PAGEWOOD GREEN STAGE 2 MASTER PLAN
PLANNING PROPOSAL

PEER REVIEW

Prepared for Bayside Council by

In July 2017 Hill Thalys was engaged by Bayside Council to assess Meriton's revised master plan for Pagewood Green Stage 2 (referred to in this document as "**Revised Proposal**"). This follows earlier work undertaken by Hill Thalys to produce a comprehensive Urban Design Study for the site in 2016.

4.5 HISTORIC AND CHARACTER ELEMENTS

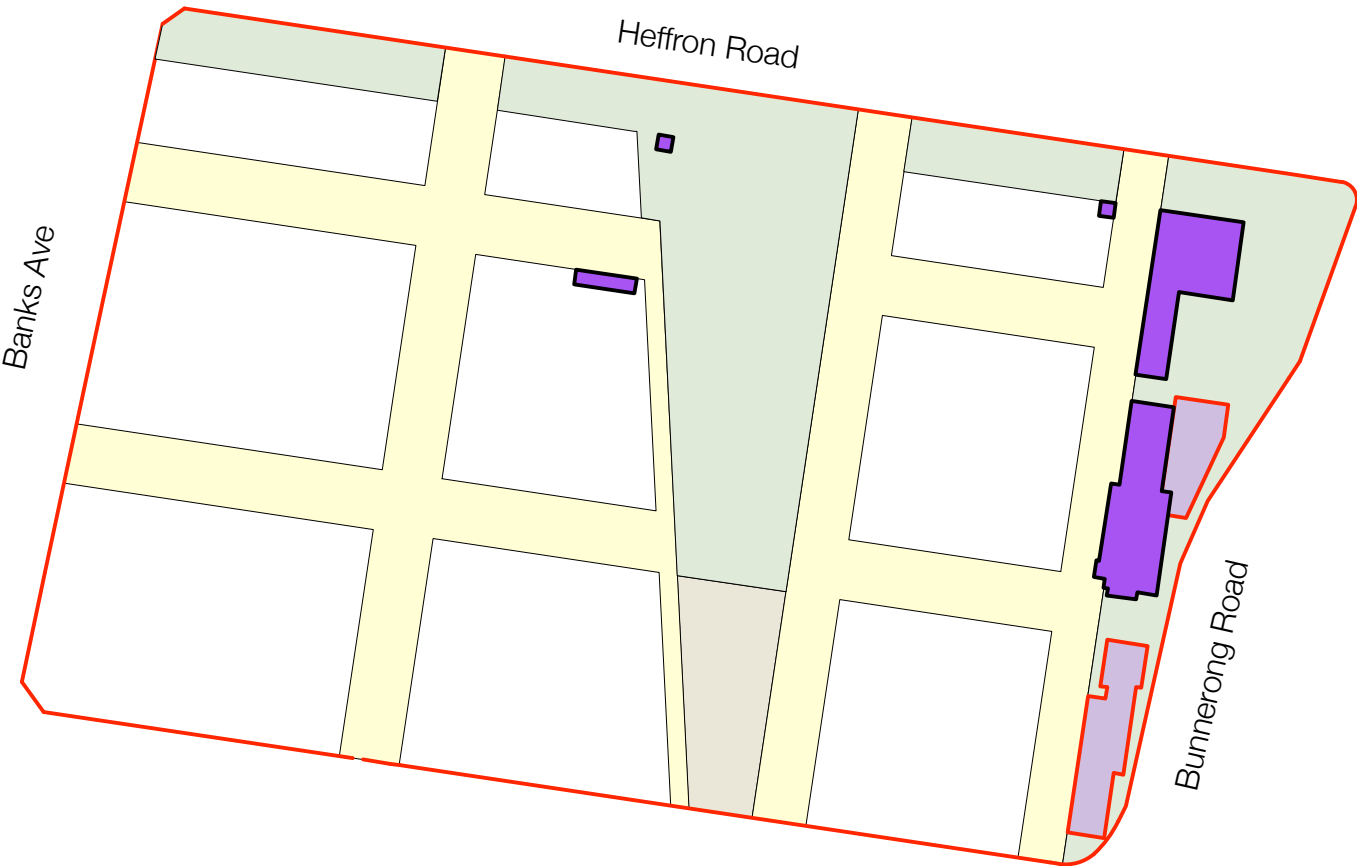
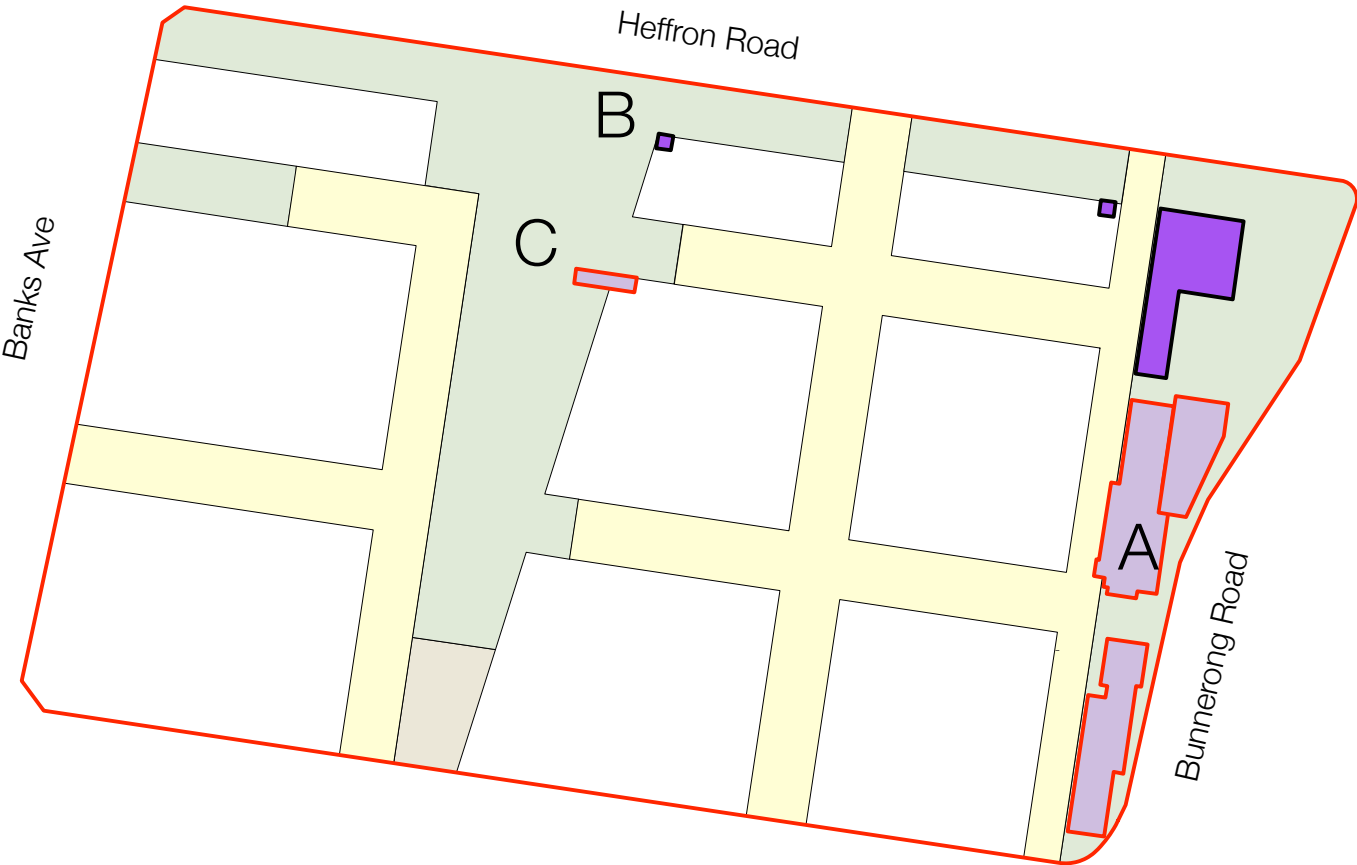
- The number and presence of heritage items along the Bunnerong Road frontage is greatly reduced (A). This limits the presence and understanding of the buildings as an ensemble and representation of use of the site over time.

The resultant new park is thin in proportion and not readily useable. It is also adjacent to significant traffic on Bunnerong Road. This historic fabric should be maintained to provide a buffer to traffic and also allow activation to the lane as well as a variety of potential mixed, retail or community uses to enliven the precinct, which are better suited to the Bunnerong Road frontage;

- Remnant built form in the centre of the site has differing/diminished relationships to the open space. Where smaller footprint elements are better suited as objects in the round and facades integrated into new development, the Revised Proposal reverses this.

The approach adopted by the Revised Proposal to integrate the small footprint elements (B) into new built form risks them being less recognisable. These elements should be considered 'free' and linked to any new built form only lightly.

4.6 URBAN BLOCKS

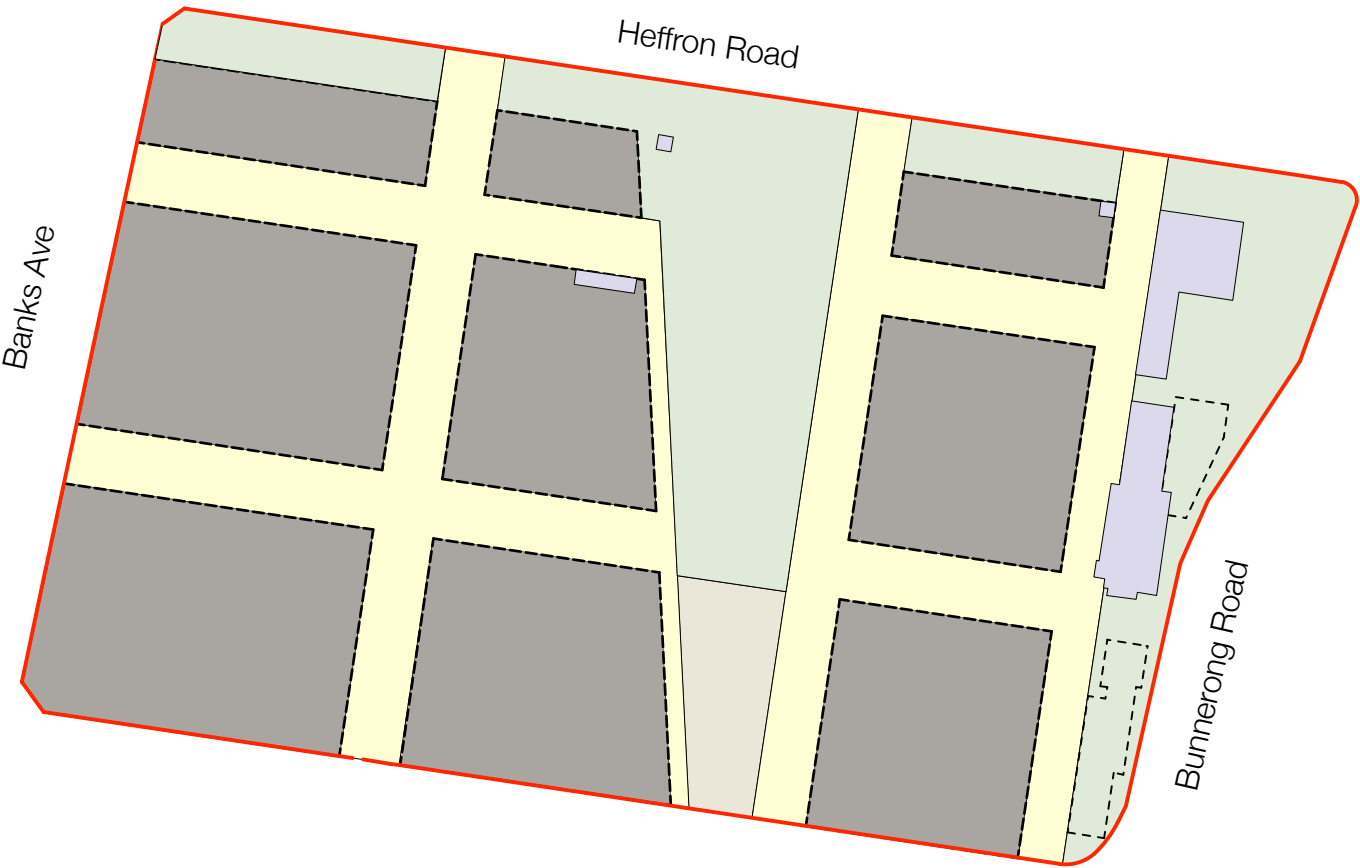
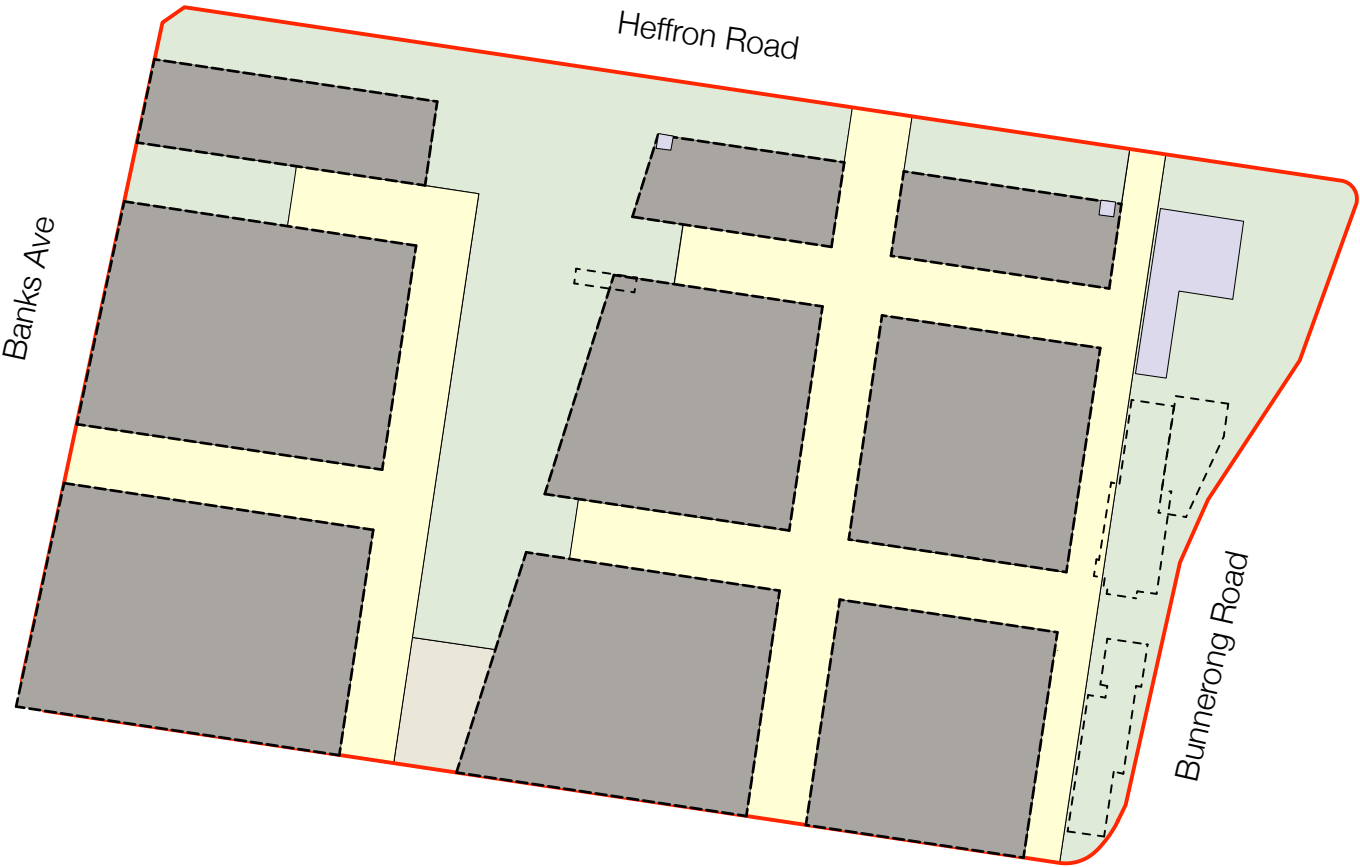
Whilst the area of urban blocks is similar, their distribution, orientation and frontage is critical to providing urban amenity and address.

The primary sources of amenity are the new wedge-park and existing Mutch Park and golf course to the west. A significant source of noise and air pollution from Bunnerong Road should be mediated by biasing development away from this source.

The Revised Proposal locates the majority of urban blocks in the eastern half of the site - further away from the major sources of amenity to the west, but closer to Bunnerong Road.

4.7 DISTRIBUTION OF BUILT FOR LOWER LEVELS

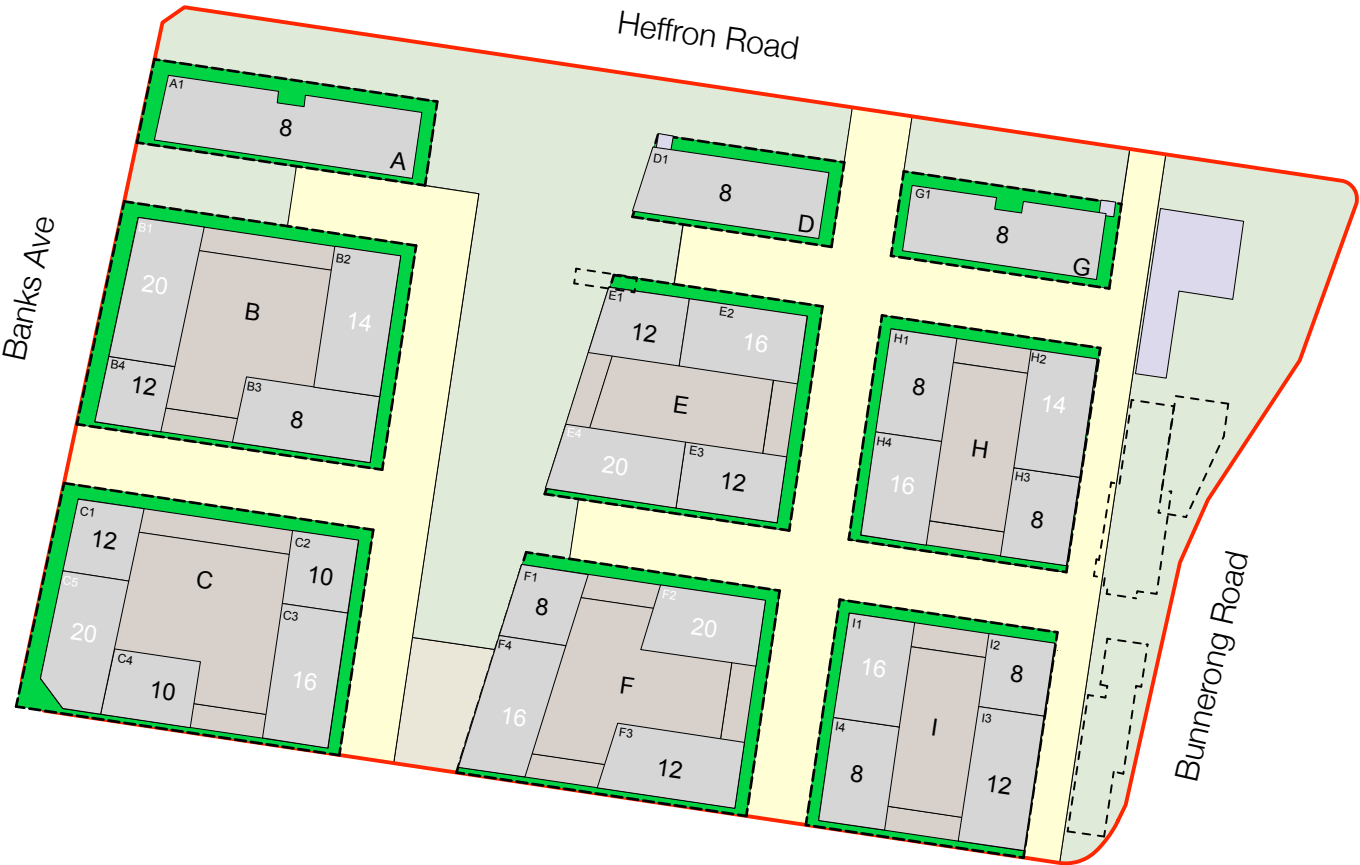
The revised proposal proposes above ground parking causing the loss of all central courtyards.

There appears no valid reason to deviate from the preferred approach, and any proposals should provide deepsoil zones, unimpeded, in line with SEPP65, the ADG and Council policies - as a minimum.

4.9 MASSING AND BULK

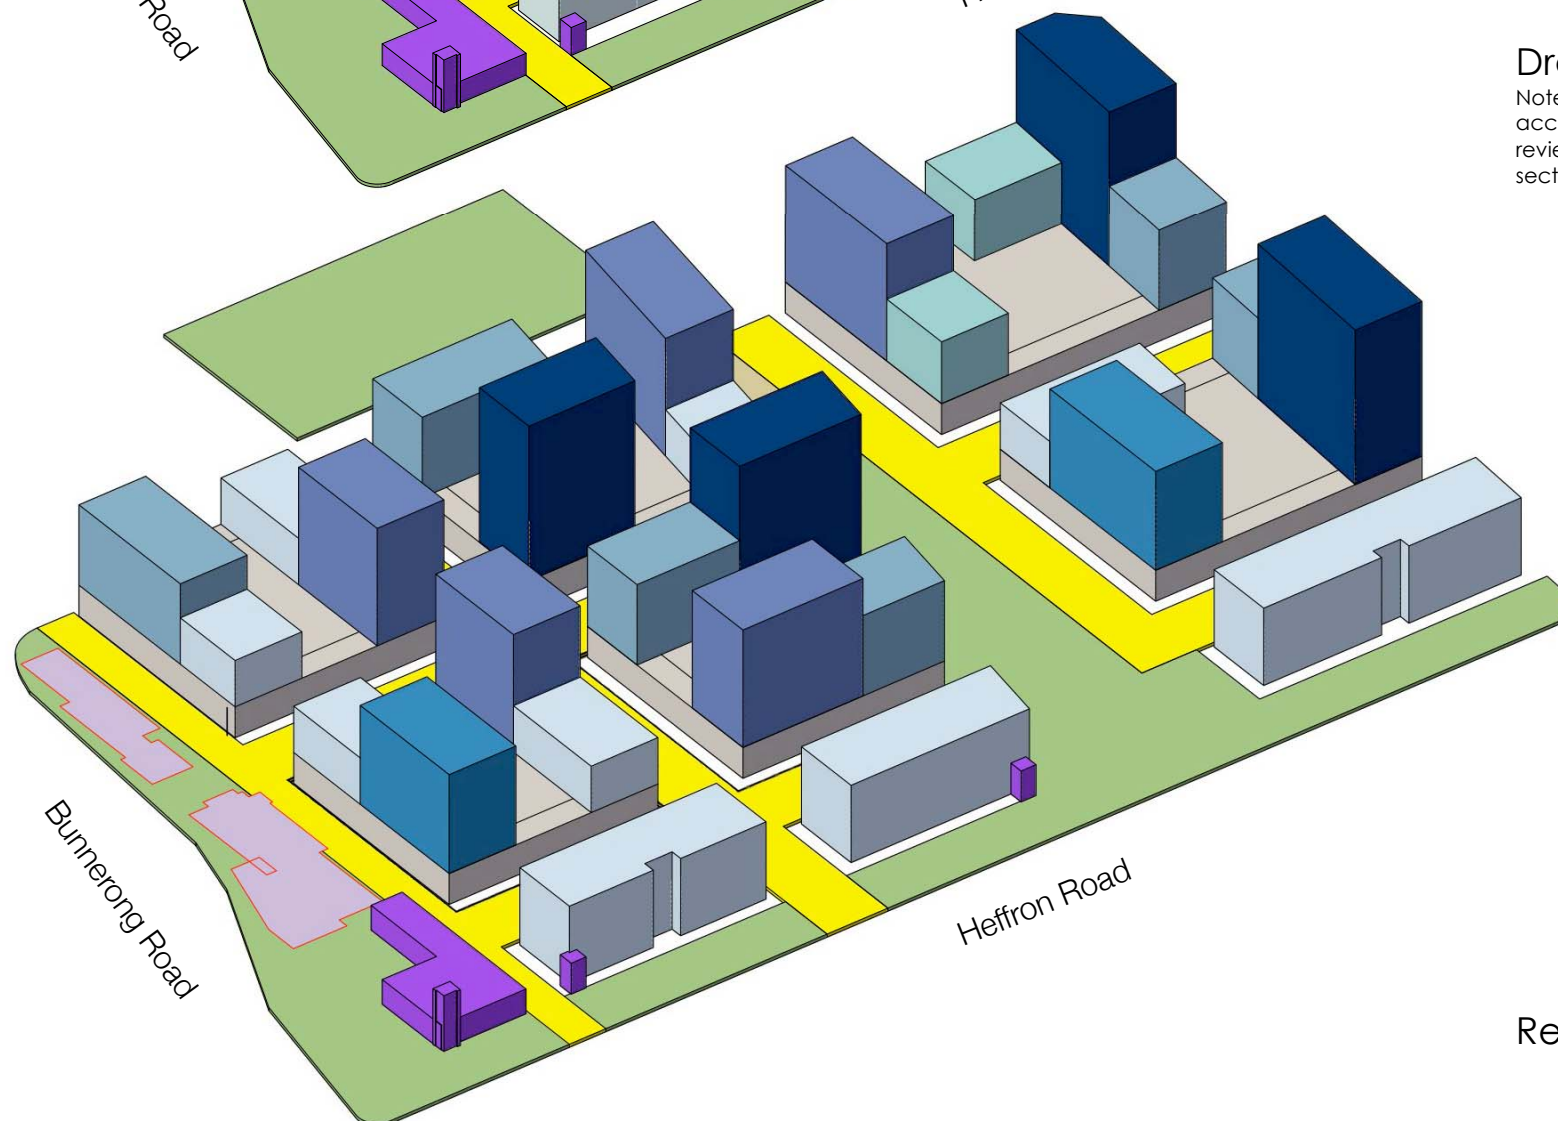
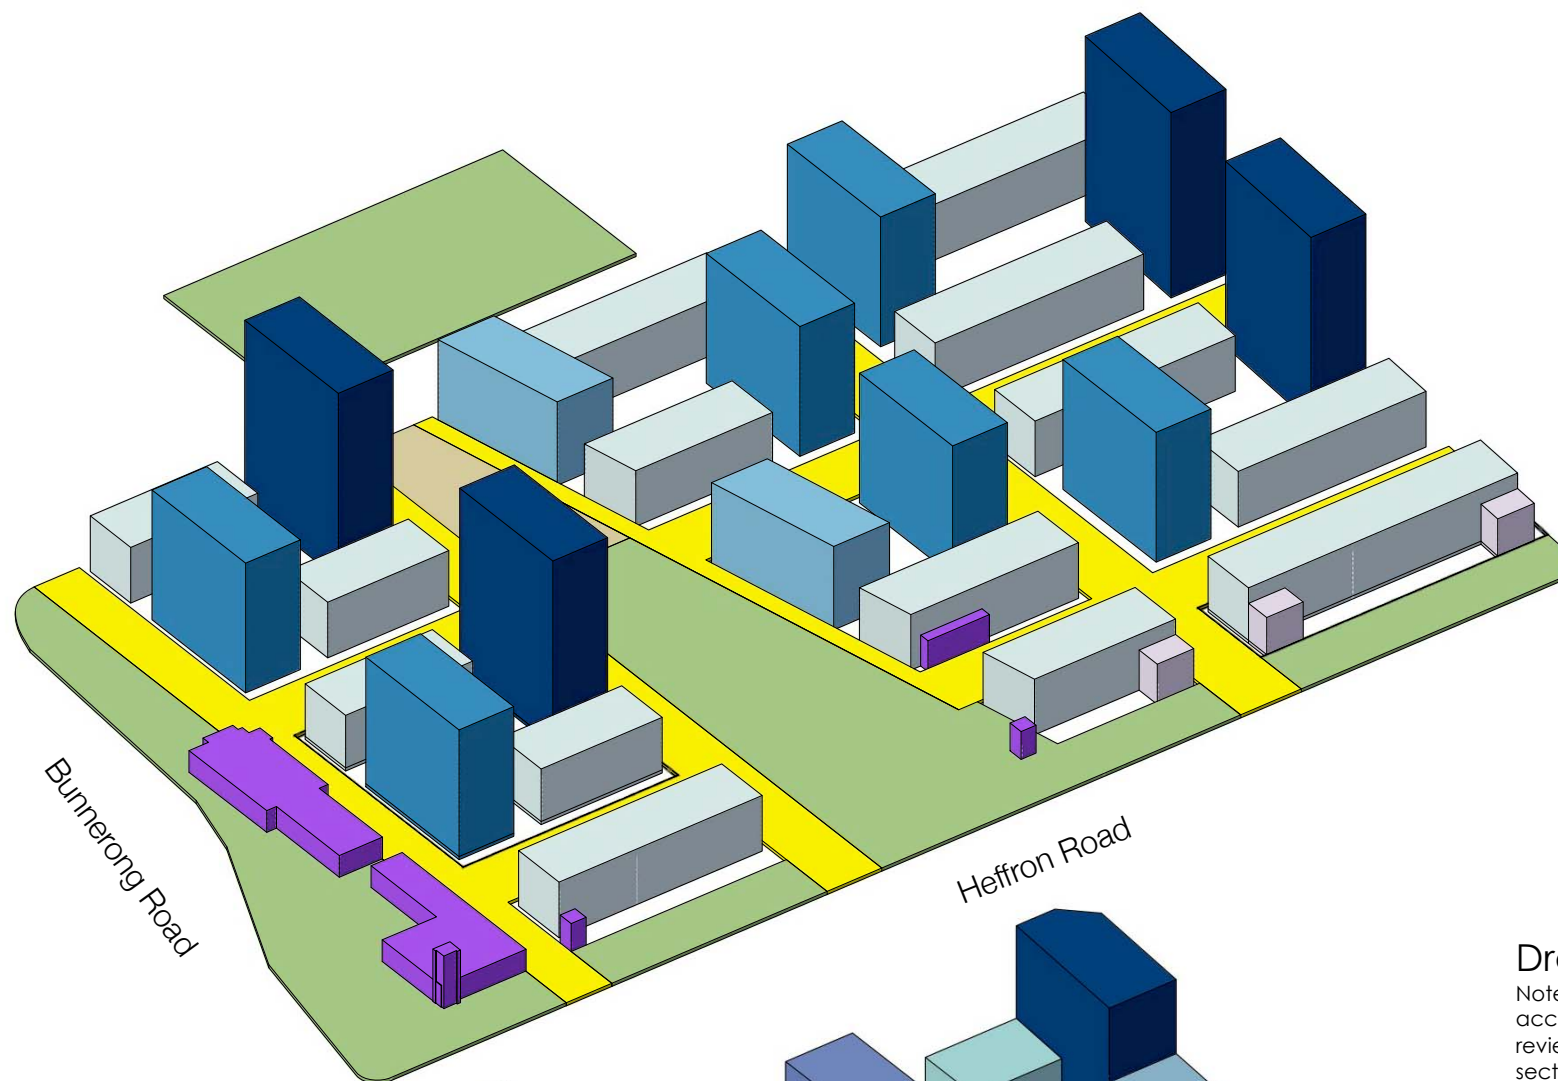
The clustering of built form within the Revised Proposal is claustrophobic and impacts highly on the availability of solar access to the public domain and dwellings at lower levels - particularly in the centre of the site.

The north south orientation and less concentrated distribution of the taller elements in the Draft Council Master Plan affords greater separation between towers for outlook, solar access and privacy as well as solar access around buildings to streets and open spaces as well as central courtyards.
